BUREAU OF LAND MANAGEMENT

Re: Deer Creek Mine Resource Recovery and Protection Plan (R2P2); Minor Modification Request, Proposed Relocation for the 4th North Mains off the 10th West Mains, North Rilda Canyon Reserve Access

ENCLOSURE 2

Minor Modification:
Proposed Location For
The 4th North Mains

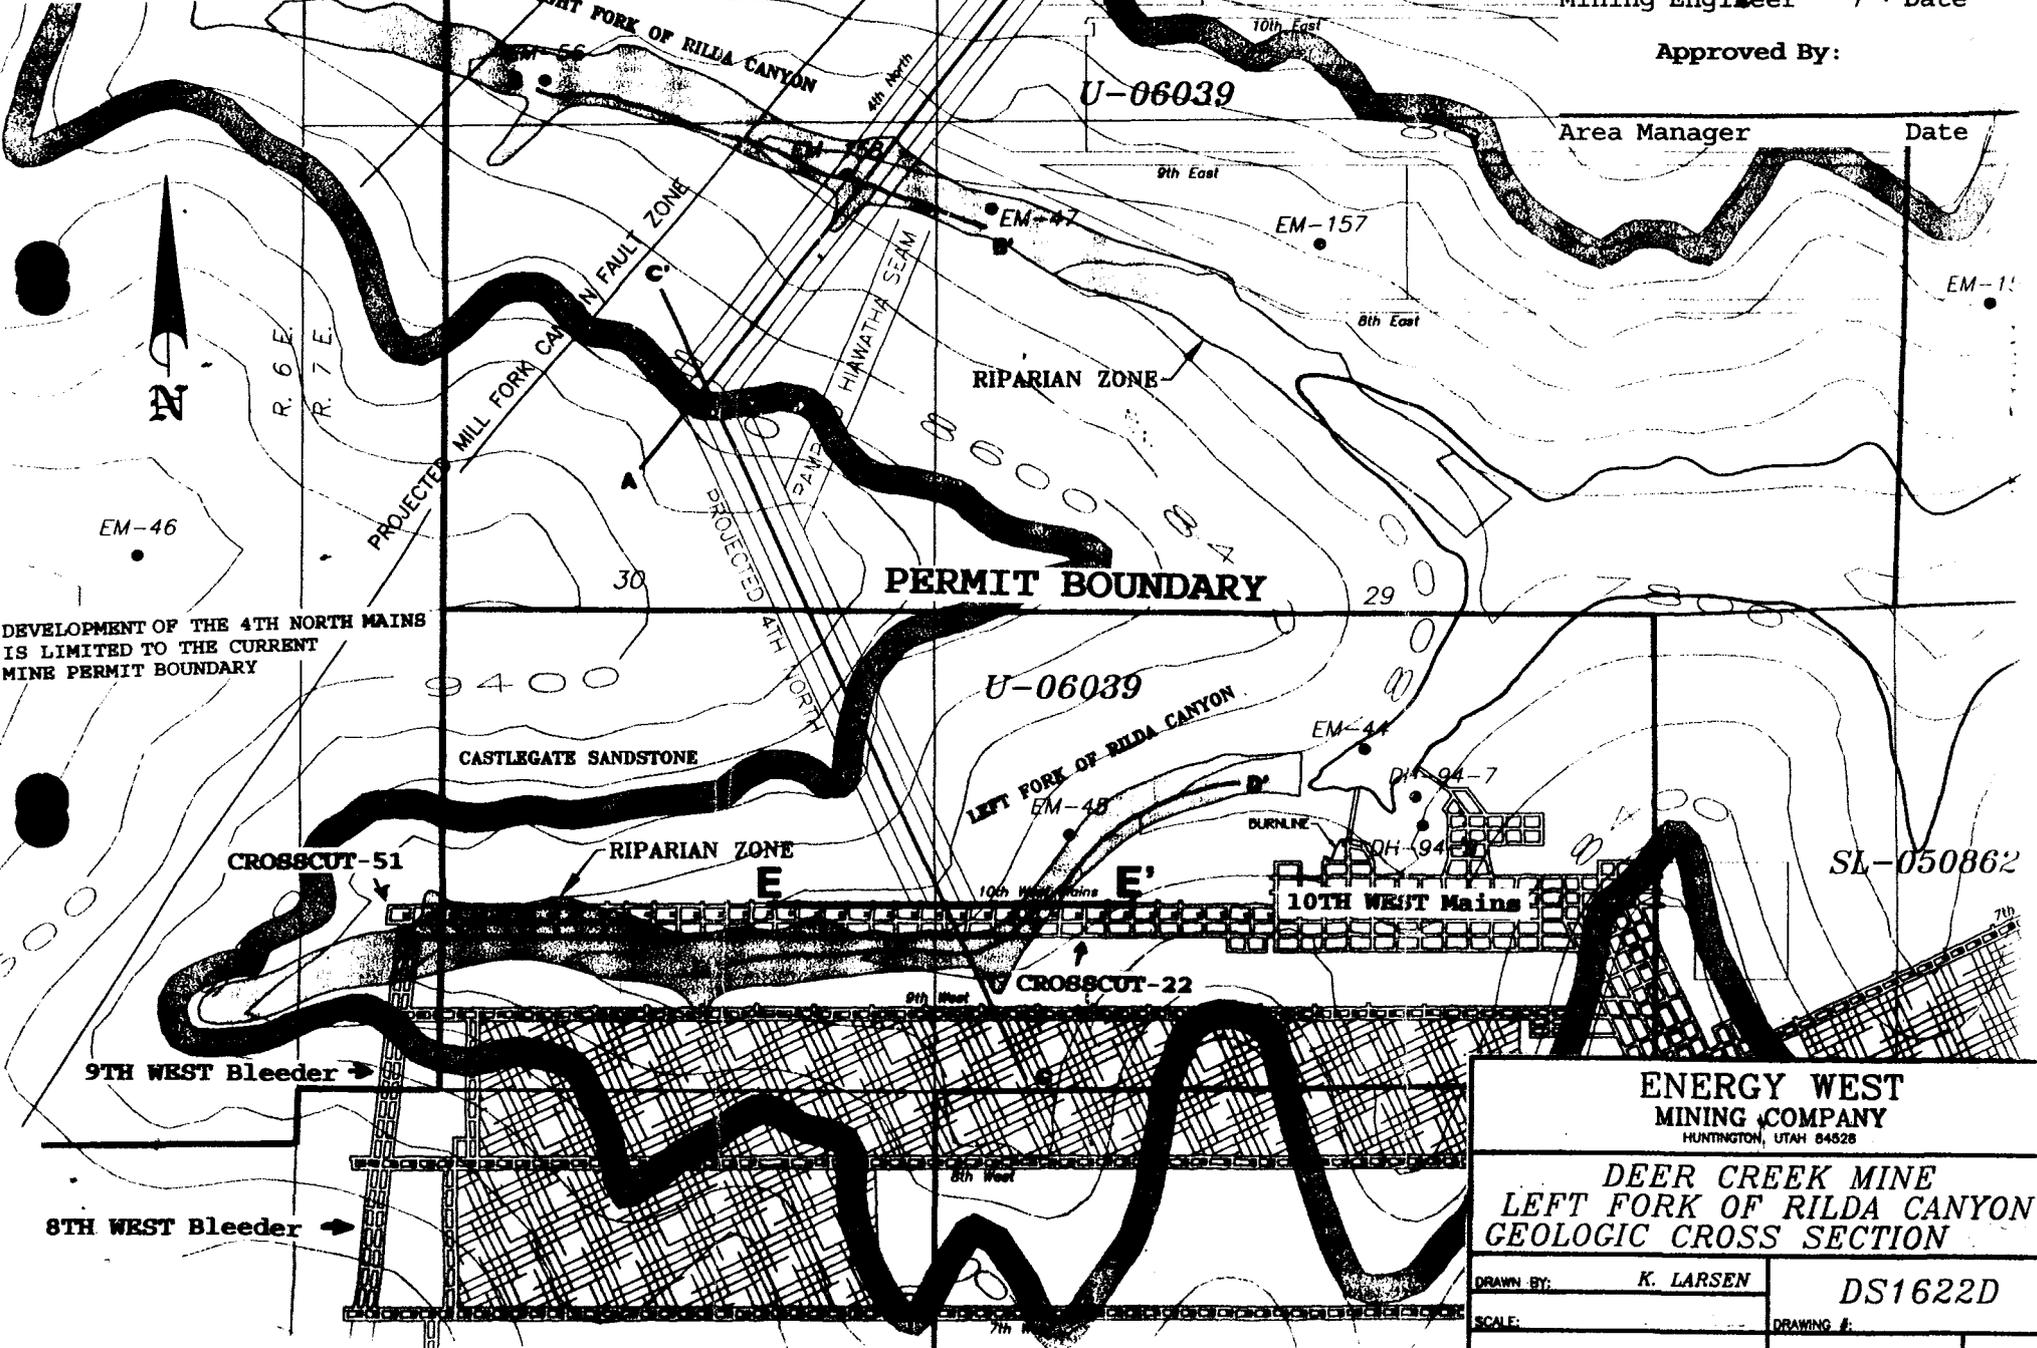
PacifiCorp's request relocates the 4th North Mains from between crosscuts 45 and 48 to between crosscuts 27 and 30 (proposed location) on 10th West. The initial development from the proposed location will be in a northwest direction for approximately 3000 feet, and then shift to a northeast direction and run parallel to the Mill Fork fault, as indicated in the approved R2P2. Accordingly, the proposed development is also limited to the **current mine permit boundary** (Enclosure 2).

The immediate floor at the approved location is comprised of a mudstone split, ranging from 1.0 to 1.5 feet in thickness and underlain by a weak/thin (less than 0.5 foot) coal rider. Floor conditions, as such, have been determined as unsuitable for the location of the mainline intersection of 10th West and 4th North.

After completion of the 10th West Mains, an attempt to locate the Mill Fork fault by in-seam drilling from crosscut 51 was conducted. The drilling was unsuccessful in delineating the fault's boundary. Consequently, additional risk for ensuring the long-term stability of the intersection at the approved location is created by the remaining uncertainties associated with the Mill Fork fault (extent of fracture zone and/or sympathetic faulting and the exact location of the fault unknown with regard to the approved location). Therefore, the decision to relocate the 4th North Mains becomes essential.

Developing the 4th North Mains as proposed will provide for a shorter belt haulage route, approximately 3000 feet shorter. Also, the total length of the 4th North Mains which is to be developed parallel to the projected Mill Fork fault graben area (a zone of many uncertainties and unstable ground conditions), as required in the approved R2P2, will be reduced by approximately 3000 feet.

In conclusion, BLM concurs with PacifiCorp on the proposed location for the 4th North Mains. Our decision is based on the following observations: the proposed location 1) provides an area of more suitable seam conditions; 2) appears to be a more stable location with regard to the proximity of the Mill Fork fault; 3) affords a shorter belt haulage route; 4) reduces main line development along the Mill Fork fault graben area; and 5) previously approved R2P2 mine plans for the area in question (Drawing CM10857 DR, dated December 15, 1993) indicate that PacifiCorp would accessed the North Rilda reserves from approximately the same location. However, at this time, BLM requests/stipulates that:

PacifiCorp shall submit a written evaluation documenting entry and pillar stability for the Rilda Canyon Fork area. The specific areas to be addressed are the **4th North Mains in the Blind Canyon seam** and the **Access Entries to the Hiawatha seam reserve** where the entries pass under the riparian zones, as illustrated on Enclosure 2. The evaluation shall determine whether additional secondary entry support is needed to prevent the occurrence of surface impact due to mining. The evaluation shall be submitted 60 calendar

The BLM has determined the proposed **Minor Modification Request**, "The Proposed Location For The 4th North Mains," as stipulated, does comply with the Mineral Leasing Act of 1920, as amended, the regulations at 43 CFR 3480, the lease terms and conditions, stipulations, and will achieve MER of the Federal coal. Therefore, approval is granted for the proposed location of the 4th North Mains. This approval confirms verbal approvals given on January 6, 1997, regarding this matter.

DEVELOPMENT OF THE 4TH NORTH MAINS
IS LIMITED TO THE CURRENT
MINE PERMIT BOUNDARY
